Celtic Renewables Grangemouth Plc Caledon Green Exemplar Plant

Permit Application

PPC/A/1193001

Figure 7.6: Ground Level Contour of the VOCs as Benzene

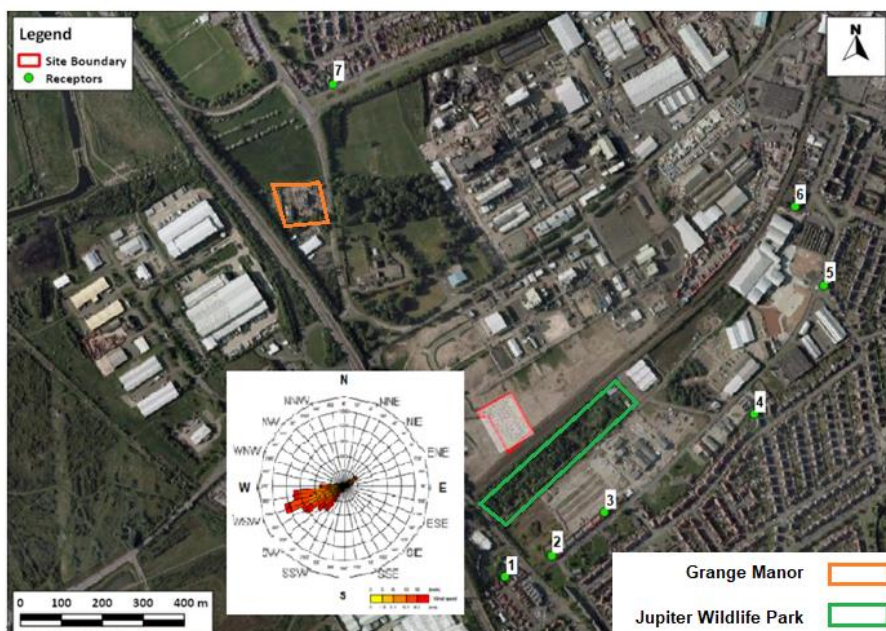
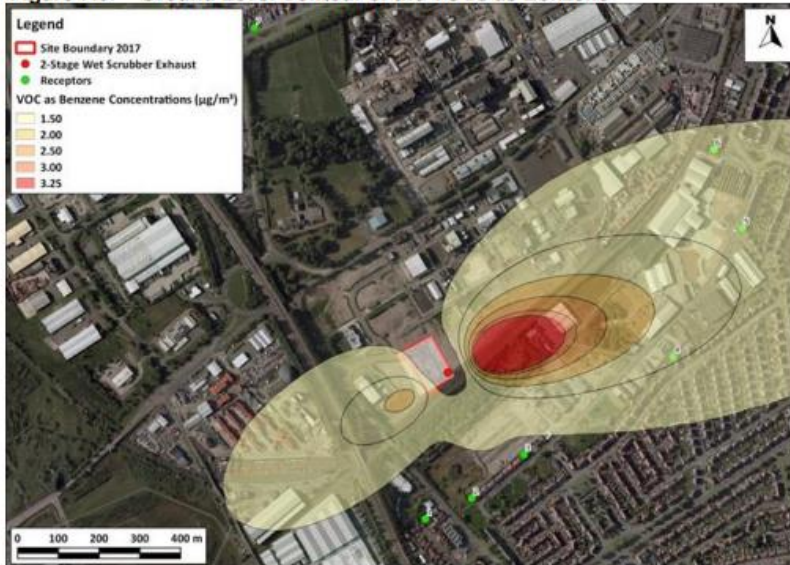
S4 FIN Query 8 b): Provide a report on further odour modelling assessment in ADMS for acetone, ethanol, n-butanol, 2-butanol and dimethylamine. Results should be specified in ug/m3. This should include a wider grid area and modelling of impacts at specific sensitive receptors including Jupiter Wildlife Park, Grange Manor Hotel, and all of the receptors shown in the original modelling assessment (Ref. Figure 7.2 in Section 7.5 of Chapter 7 – Air Quality in the EIA) and comparison of results to the odour thresholds for each of these VOCs

contribution (in ug/m³) to each of the parameters modelled. As per Section 4.1 Impact Assessment of the Guidance for Specialty Organic Chemicals Sector IPPC S4.02, indicative BAT requirements state that an assessment of potential impact of the total emissions from activities on receptors can be undertaken using the method laid out in IPPC Environmental Assessments for BAT (Horizontal Guidance Note IPPC H1). The methods laid out provide a systematic method by which to “identify where modelling needs to be carried out”. Following on from the assessment in line with the prescribed method, further modelling is not considered to be required.

SEPA Discussion: A review of the Earls Gate Energy Centre (Energy from Waste) PPC Part A Permit application was undertaken (the site is less than a few 100m away from the site of the proposed Caledon Plant an underwent Air modelling). Whilst the use of specific data from Earls Gate would not a valid comparison, it is useful to understand the approach taken to the air modelling at the adjacent larger and more complex site. The Decision Document for Earls Gate advised that specific modelling was not directly carried out for the Jupiter Wildlife Centre and that the decision was taken to use a review of the sensitive receptor results for the nearest human health receptors in Primrose Avenue and Wood Street directly behind the Wildlife Park. The three receptors were identified as R1, R2 and R5 in the Earls Gate report and are, according to map comparisons, identical in position to the three receptors designated 1, 2 and 3 in the Caledon Green Exemplar Plant Air modelling report (shown on the map below) and as such it is deemed reasonable to adopt the same modelling decision for the Caledon Green Plant. The Grange Manor was a receptor point identified as R18 in the Earls Gate EIA / PPC Part A Application, this is on a bearing NW of the Caledon Green Site, with the sole receptor, Receptor Point 7, on a bearing NNW of the site (it would if the maps are correct sit between R15 and R14 from the Earls Gate EIA). The results from the ADMS modelling show that although a slight impact was noted in the model for the Surrogate “VOC as Benzene” at Receptor Point 3 (see Table below) this was for an unabated release in a worst-case scenario is worst case (benzene is not present in the off gas). The calculations of emissions provided from the screening under the H1 assessment indicate that the unabated emissions are deemed insignificant (albeit VOC as Benzene was screened out at stage 2 of the assessment) and therefore were screened out as NOT requiring further modelling as not requiring further modelling.

SEPA Decision: Given the result of the H1 assessment, the negligible impact from the ADMS modelling the calculation based on unabated releases and the subsequent installation of two stage abatement equipment Further modelling is deemed unnecessary under the Guidance

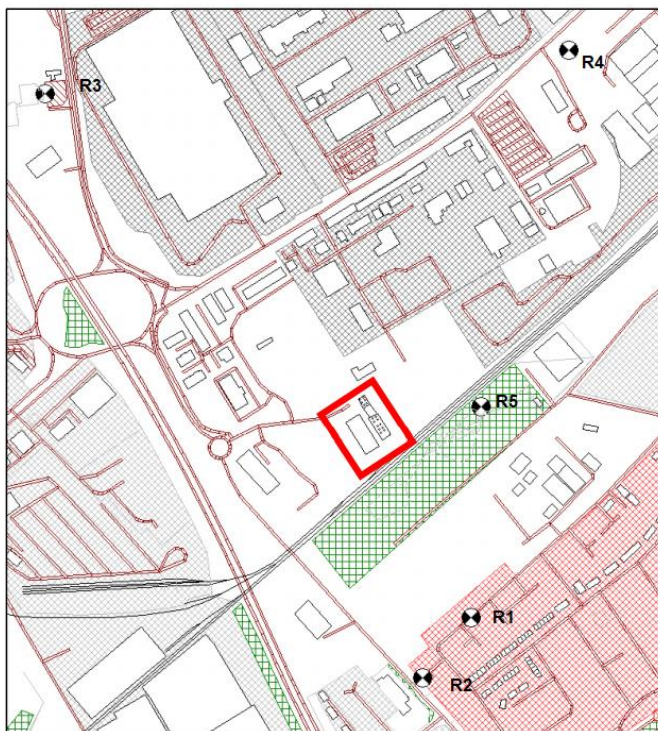
S4 FIN Query 2. The noise report submitted alongside the application does not clearly identify appropriate locations of receptors in the model. The report should be revised to include, as a minimum, the Jupiter Urban Wildlife Centre and the closest housing as reference points. (Good examples of noise reports from sites close to the proposed installation may be useful in identifying the closest sensitive Receptors and can be provided if requested)

SEPA Decision: A review of the report identifies that all the elements of the S4 Fin Query 1 have been complied with and the noise maps and plans and with the emission points identified have been provided

along with the predicted movement of LGVs on the site. The ones pertaining to the site layout are included in the appendices to the permit for use in the regulation of the site.
